E8364B-01B**S E R V I C E****N O T E**Supersedes:
E8364B-01A**E8364B PNA Series RF Network Analyzers**

Serial Numbers: 00000000 thru 46999999

July 26, 2007

Figure 1

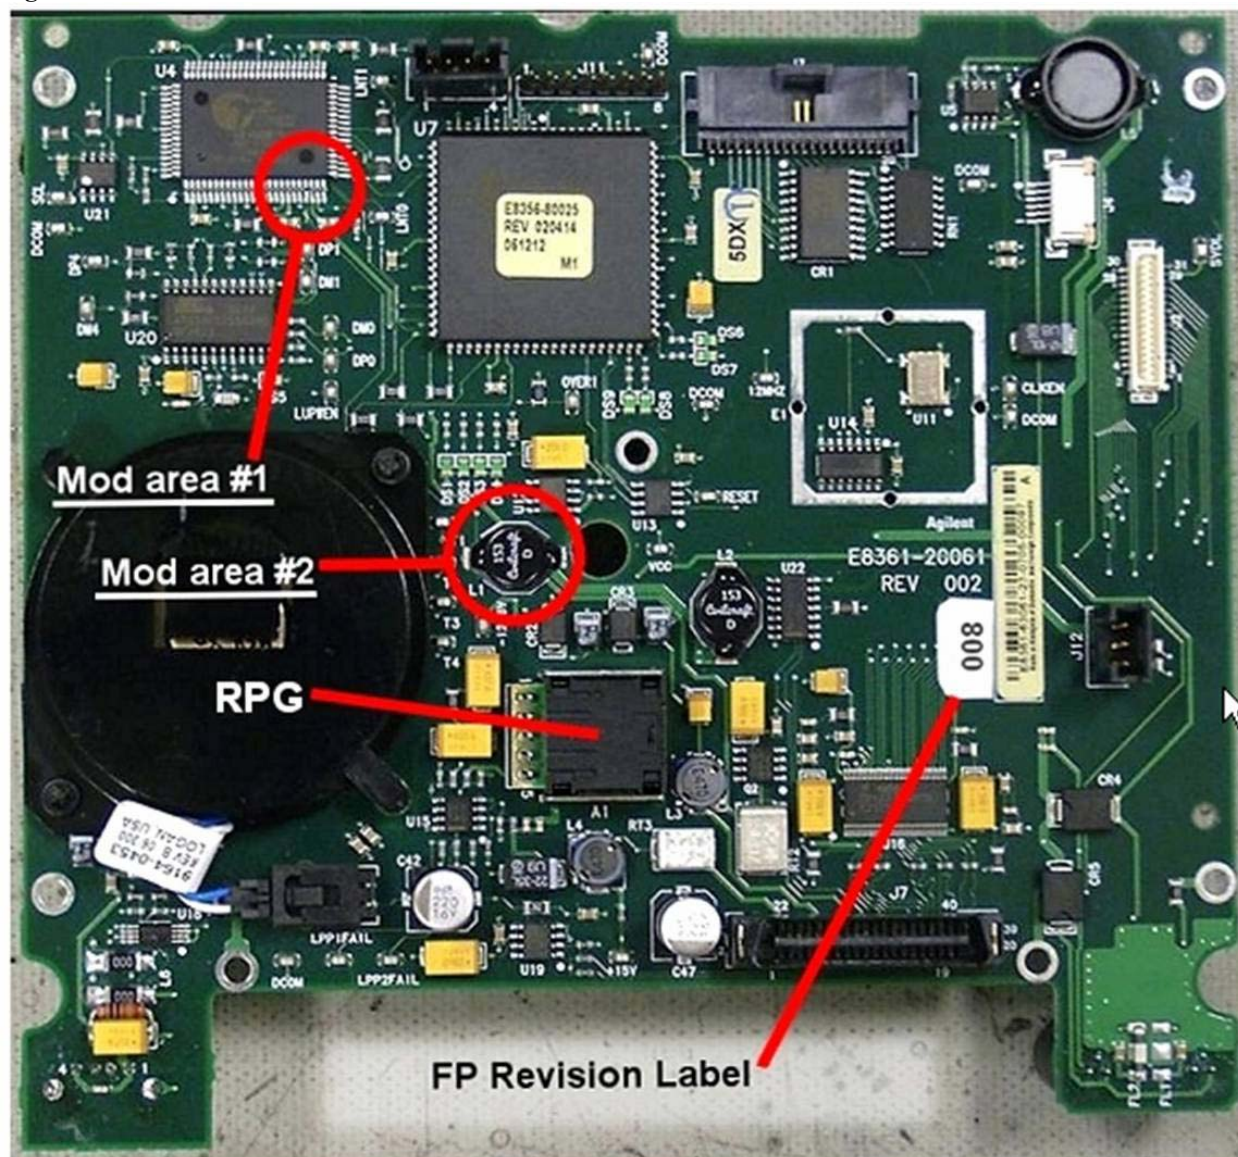
Refer to Figure 1 for the two modification areas to be addressed. Note that while this picture happens to show the FPI board completely removed from the front frame assembly, this is not necessary to perform the required modifications.

- Modification #1 consists of shorting two pins of U4 together with a small amount of solder.
- Modification #2 consist of removing L1.

Unsolder and completely remove the black surface mount inductor L1 from the front panel assembly board. This is no longer needed and can be discarded.
